**Application for SPECIAL PERMIT Review by the Planning Commission**

<b>Part 1 - Project and Sponsor Information</b>							
Name of Action or Project: Recess Coffee Tenant Build-out							
Project Location (describe, and attach a location map): 429 Ulster Street / 122 Milton Ave							
Brief Description of Proposed Action: RENOVATION OF A CORNER RETAIL SPACE WITHIN AN EXISTING TWO-STORY MIXED USE BUILDING INTO A COFFEE SHOP THAT WILL ALSO SERVE FOOD AND ALCOHOL. THE AREA BEING RENOVATED WAS PREVIOUSLY A COFFEE SHOP AS WELL, SO THERE IS TO BE NO CHANGE OF OCCUPANCY. THE SPACE IS VACANT AND LARGELY WIDE OPEN, SO LITTLE DEMOLITION WORK IS REQUIRED. THE EXTERIOR WORK INCLUDES SOME REPLACEMENT WINDOWS AND COSMETIC MATERIAL AND SIGNAGE ATTACHED TO THE EXISTING FACADE. NO OTHER WORK IS TO TAKE PLACE OUTSIDE OF THE TENANT AREA AS PART OF THIS PROJECT.

**Re: Special Permit application for 429-431 Ulster Street**

# RENOVATIONS TO STOREFRONT AT 112 MILTON AVE, SYRACUSE, NY FOR RECESS COFFEE

**CODE SUMMARY DRAWINGS**

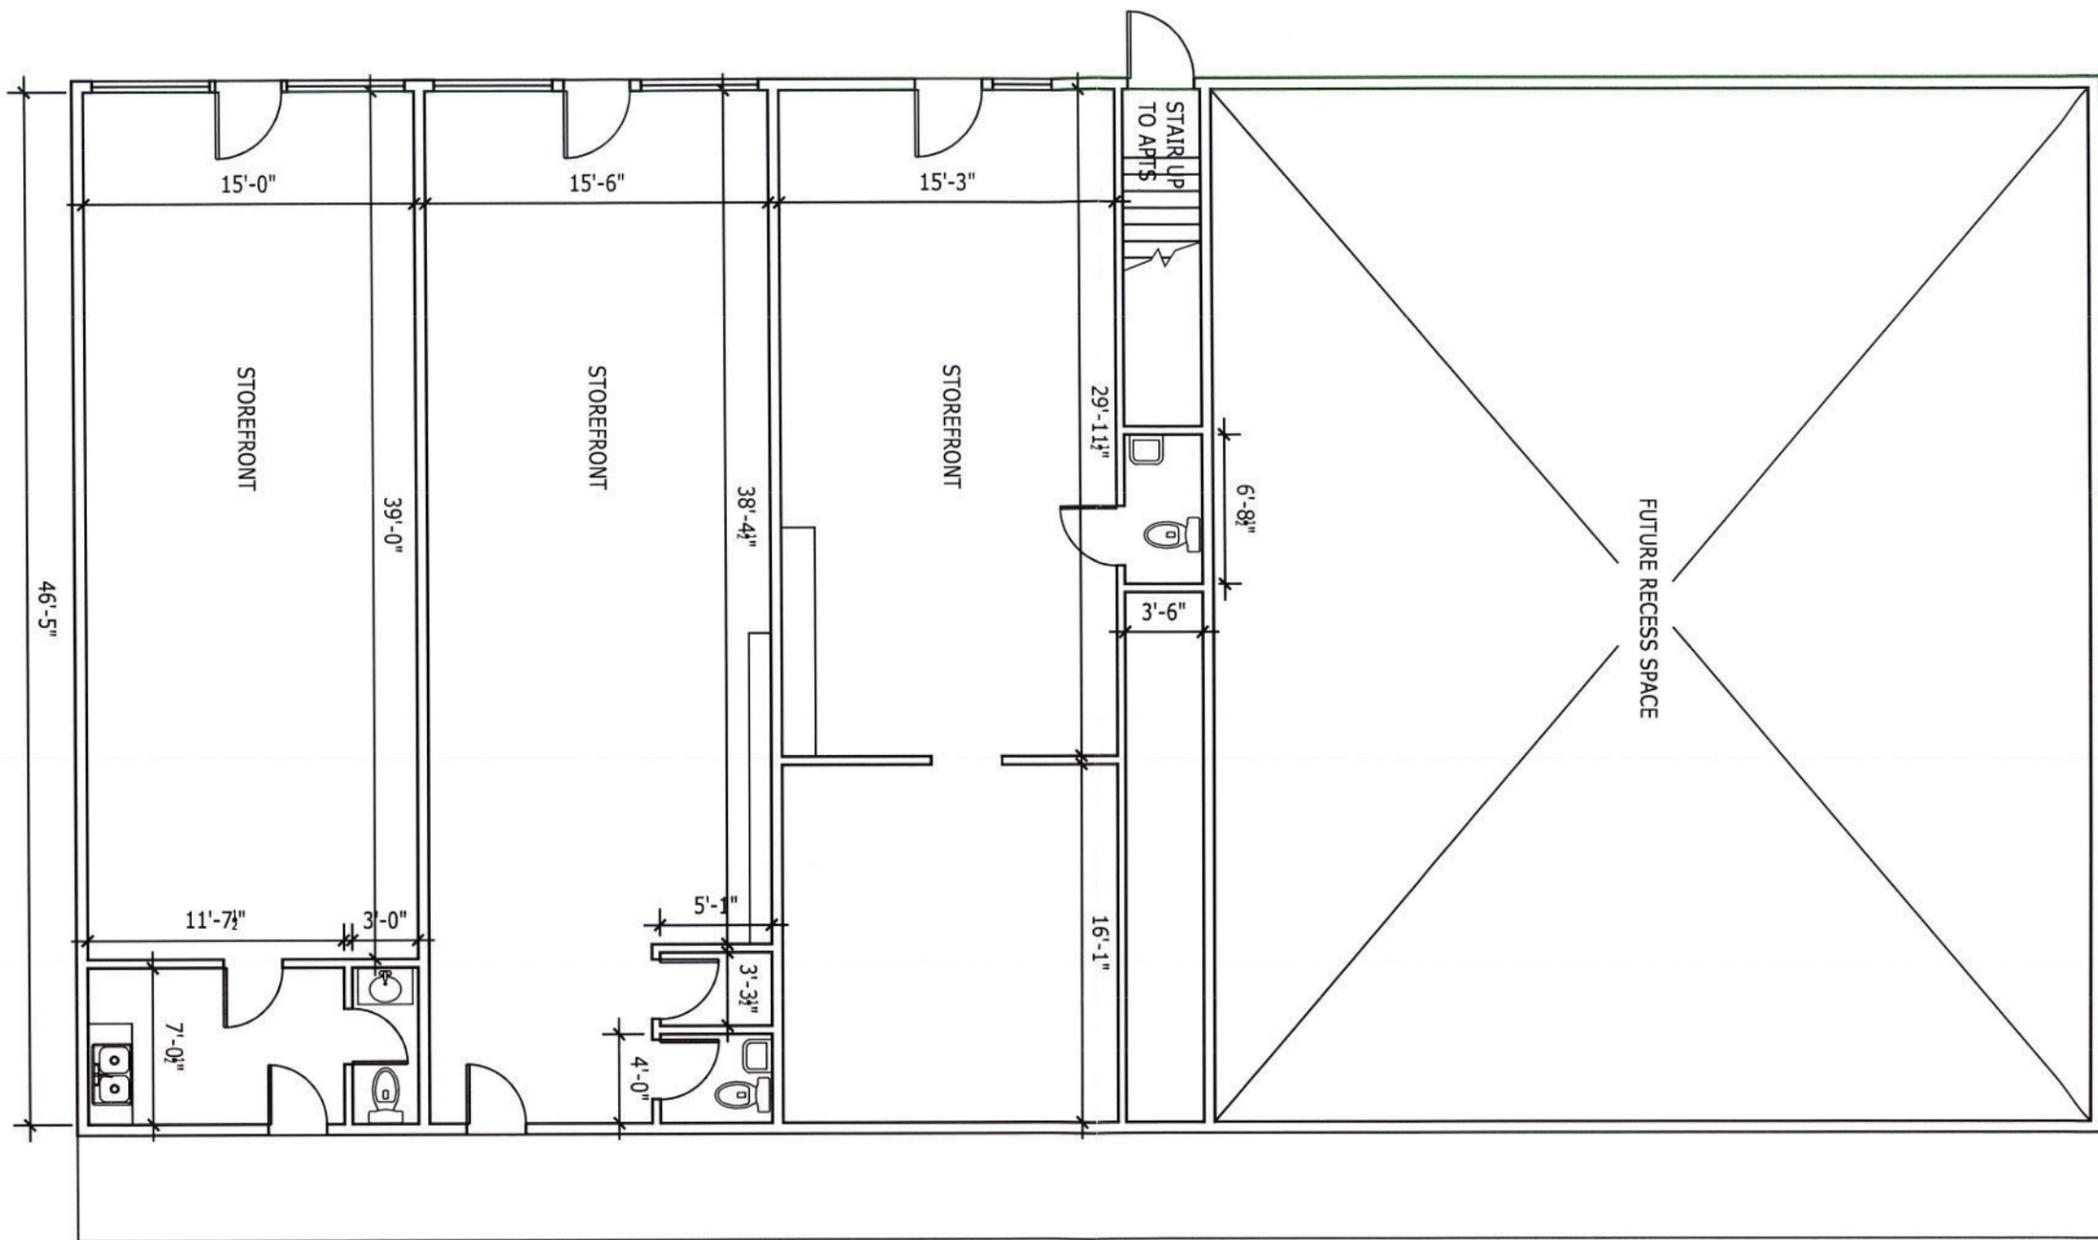
- Floor plans – The original application contained a floor plan for only the portion of the building which Recess is planning to occupy. You required a floor plan for the entire ground floor. Enclosed please find an amended floor plan that shows the entirety of all four first-floor commercial spaces.
- Exterior signage drawings & Exterior elevations – The type, size and location of the three proposed signs are now included in a new exterior elevation drawing included in this submission.
- Specifications – These were part of the original application, but you may have questions as to the many specification components that were included. Please let us know if have questions or concerns about any of the content of these specifications.

**2** EXTERIOR ELEVATION - NORTH  
1/4" = 1'-0"

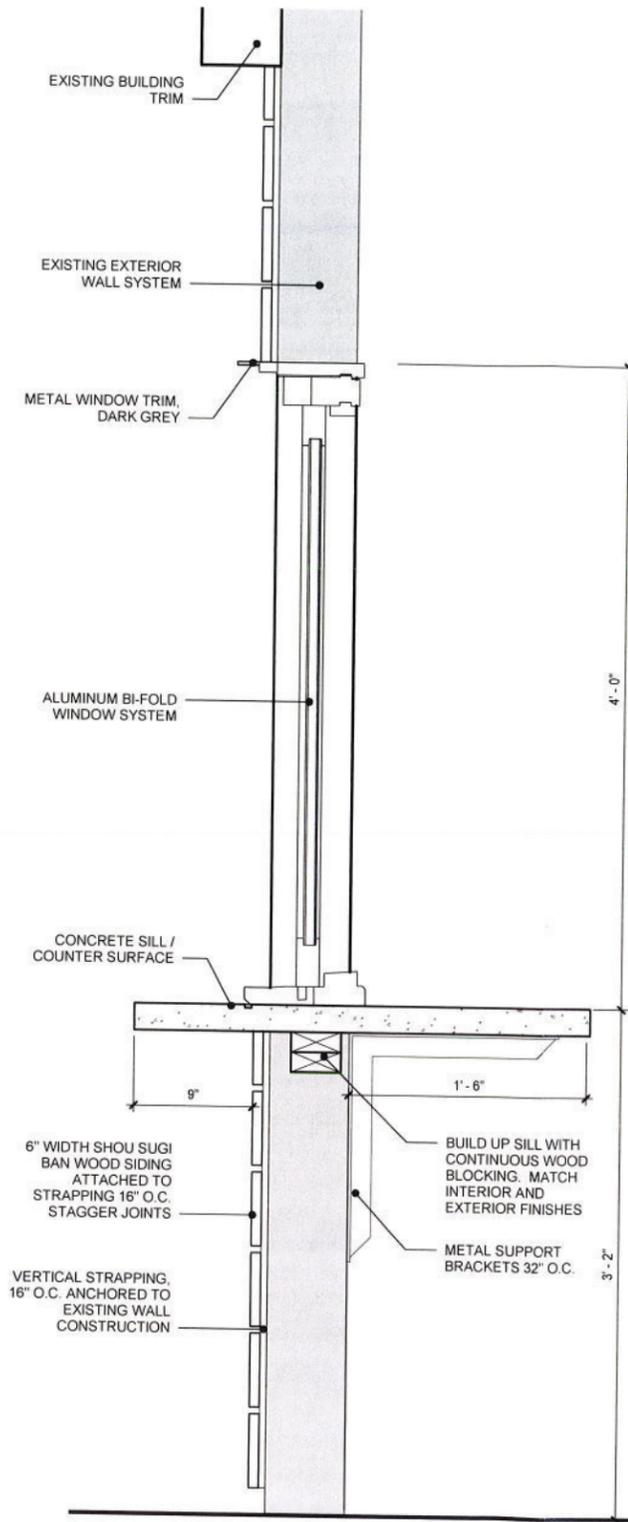
- CHECK ACCESSIBILITY FOR SERVICE COUNTERTOP; DRAINAGE AREAS.
- VERIFY HOOD EXHAUST DISCHARGE LOCATIONS.

HOOD EXHAUST TERMINATION LOCATION, MINIMUM 10' ABOVE ADJACENT GRADE, MINIMUM 10' AWAY FROM ADJACENT PROPERTY LINE, MINIMUM 3' FROM ANY ADJACENT EXTERIOR OPENINGS/WINDOWS REFER TO MECHANICAL CODE SECTION 506.3.13
